Drax Power Limited's proposed facility is located at Millbrook Power Station, Rookery Pit South, Stewartby, Bedfordshire, MK43 0PR. We refer to this as "the **Installation**" in this document.

1. Our decision

The Permit uses the DEFRA LCP reference numbers to identify each LCP. The LCP permitted is as follows:
LCP650

Graph showing stack height sensitivity testing.

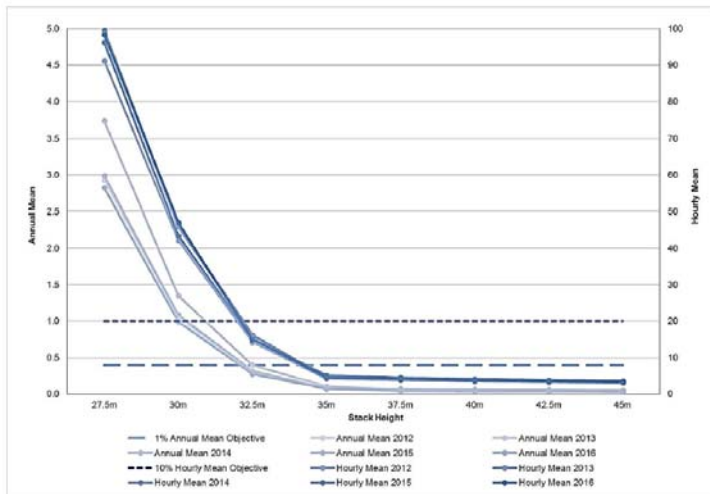
Stack height sensitivity testing indicated that a stack height of 32.5m would be required to achieve adequate dispersion of emissions, with the maximum ground level concentrations within the receptor grid as insignificant – see graph below. We accept that this indicates BAT for stack height.
